Publication Number. MA3239-M01

MODIFICATION INSTRUCTIONS

KODAK MINILOADER 2 PLUS,

MODIFICATION No. M01

FIGURE 1

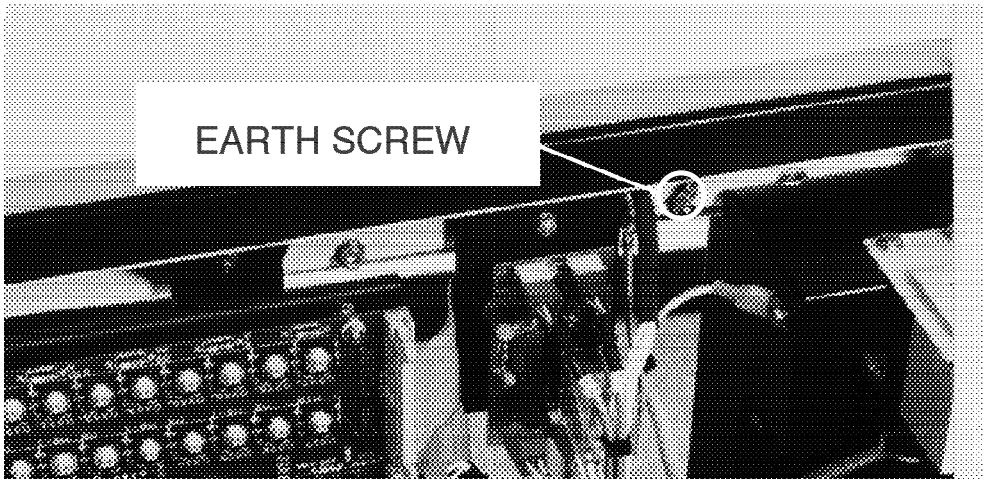
To fit new star washers to the main earthing screw of the Miniloader to ensure satisfactory earthing.

3. Locate the EARTHING SCREW indicated in FIGURE 1. Carefully peel back the LIGHT SEAL STRIP to gain access to the SCREW HEAD, and remove the SCREW.
